Access Compliance Report
Public Rights-of-Way
(Curb Ramps)

Intersection ID: 43641	**Main Street:** HUNTINGTON_MEADOW_LN	**Cross Street:** KENDRICK_CROSS_RD	**Location:**	**NW**
ADA ID: A64A44BD41D0	**Ramp Type:** PerpDiag	**Initial Pass/Fail:** Fail	**Overall Compliance:** No	**Severity Score:** 8.75

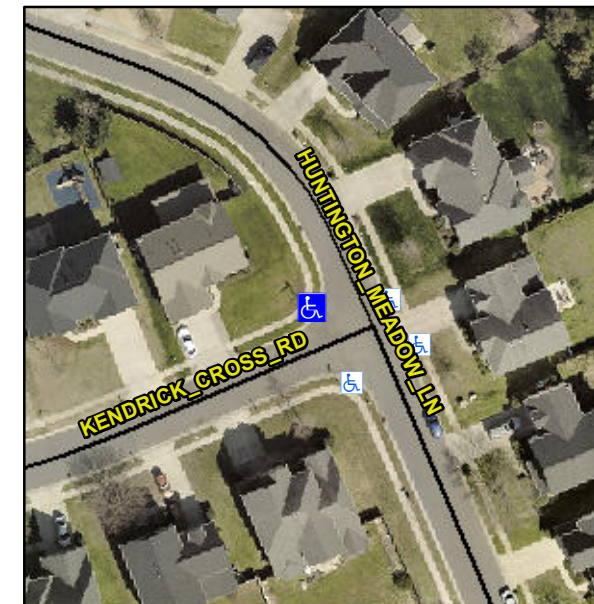
Not Found, R304.5.1

Compliance	Description	Data	Compliance	Description	Data
N/A	Ramp Length (in)	96.0	Yes	Ramp Slope (%)	6.4
No	Ramp Width (in)	38.0	Yes	Ramp XSlope (%)	1.6
N/A	Flare Type LT	N/A	N/A	Flare Type RT	N/A
N/A	Flare Slope LT (%)	N/A	N/A	Flare Slope RT (%)	N/A
N/A	Flare Traversable LT?	N/A	N/A	Flare Traversable RT?	N/A
N/A	Landing Length (in)	N/A	N/A	DWS Provided?	N/A
N/A	Landing Width (in)	N/A	N/A	DWS Contrast?	N/A
N/A	Landing Slope (%)	N/A	N/A	DWS Length (in)	N/A
N/A	Landing X Slope (%)	N/A	N/A	DWS Full Width?	N/A
N/A	Landing Curb? (Y/N)	N/A	N/A	DWS Offset (in)	N/A
N/A	Shared Landing?	N/A			
N/A	Gutter Ponding?	N/A	N/A	Gutter Slope (%)	N/A
N/A	Gutter Lip Ht (in)	N/A	N/A	Gutter X Slope (%)	N/A
N/A	Painted X Walk1?	No	N/A	Painted X Walk2?	No
	X Walk 1 Direction	To S		X Walk 2 Direction	To E
N/A	X Walk 1 Width (in)	N/A	N/A	X Walk 2 Width (in)	N/A
	X Walk 1 Slope (%)	2.0		X Walk 2 Slope (%)	3.8
	X Walk 1 X Slope (%)	0.7		X Walk 2 X Slope (%)	2.0

Remove & Replace Curb Ramp With Two New Directional Ramps or Equivalent.
